NUCLEAR REGULATORY COMMISSION

Title: Advisory Committee on Reactor Safeguards
526th Meeting

Date: Thursday, October 6, 2005

Opening Remarks by the Acting ACRS Chairman	4
Interim Review of the License Renewal	
Application for the Browns Ferry Nuclear	
Plant, Units 1, 2 and 3	6
Proposed Recommendations for Resolving Generic	
Safety Issue 80, "Pipe Break Effects on Control	
Rod Drive, Hydraulic Lines and the Dry Wells	
of Boiling Water Reactor Mark 1 and 2	
Containments"	56
Resolution of ACRS Comments on the Draft Final	
Regulatory Guide, "Risk-informed,	
Performance-based Fire Protection for Existing	
Lightwater Reactor Nuclear Power Plants"	99
Davis-Besse Reactor Vessel Head Integrity	
Calculations	144
Adjourn

NEI 04-02 Figure 5-1 Revision 0

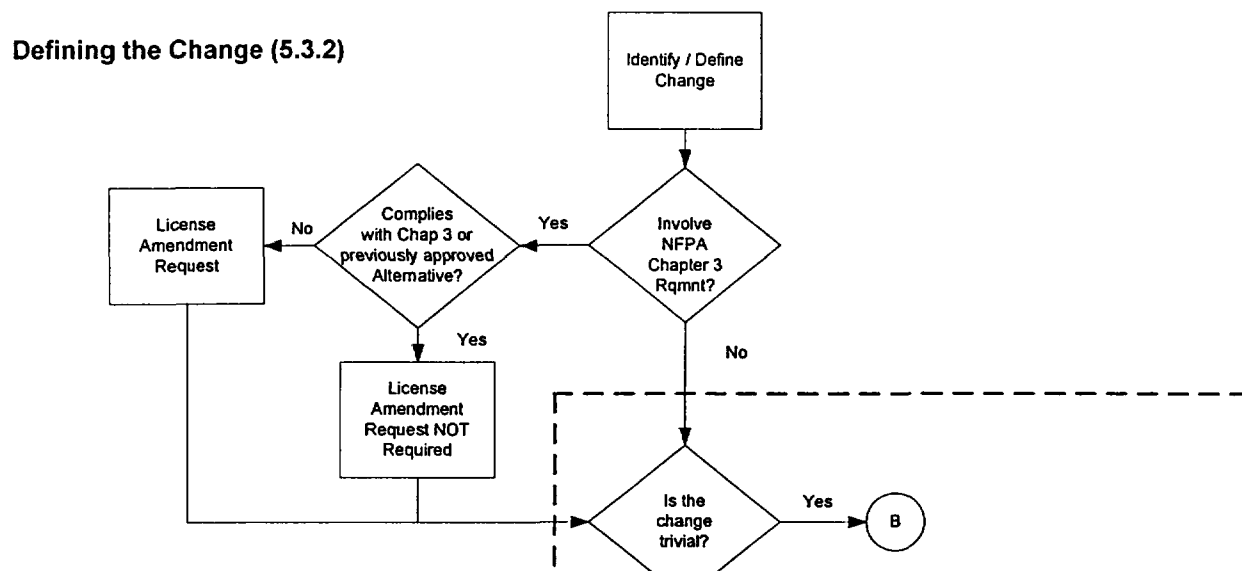
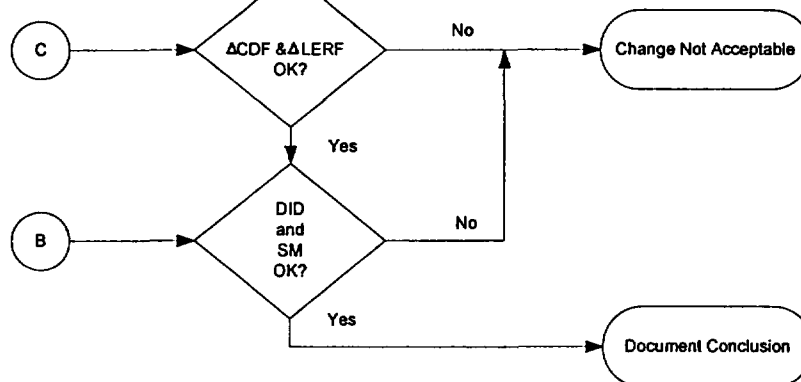
19 First specific comment was that the
20 initial fire modeling approach should not be used as
21 an alternative to estimates of changes in CDF and
22 LERF. The way we addressed this was to revise
23 Figure 5-1 in NEI 04-02 and --

9 MR. RANDLINSKI: Okay. The area of
10 concern is -- this is the plant change evaluation of
11 the process in schematic form. And this is from NEI
12 04-02. It's Figure 5-1. This was the previous
13 revision, Revision 0, which is covered up by that
14 five. The area of concern was this path here, which
15 is the approach -- the fire modeling approach to
16 evaluating a change, and it was shown as a parallel
17 path along -- in parallel with the risk assessment
18 path.

NEI 04-02 Figure 5-1 Revision 0

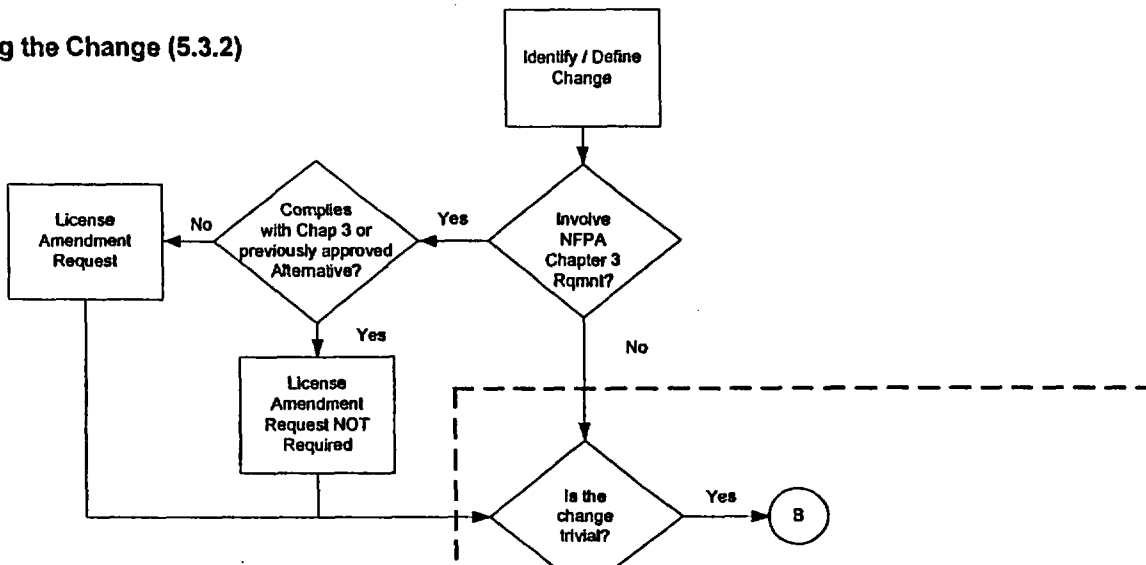
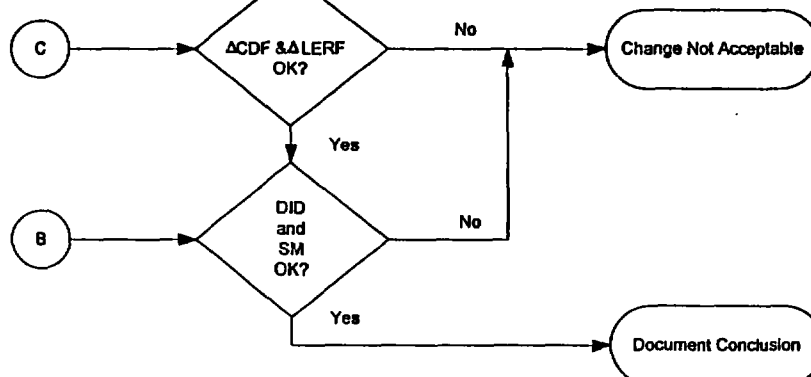
- ACRS Comment: The “initial fire modeling” approach should not be used as an alternative to estimates of changes in CDF and LERF.
- How addressed: NEI 04-02 has been revised to eliminate this approach (See revised Figure 5-1)

NEI 04-02 Figure 5-1 Revision 1
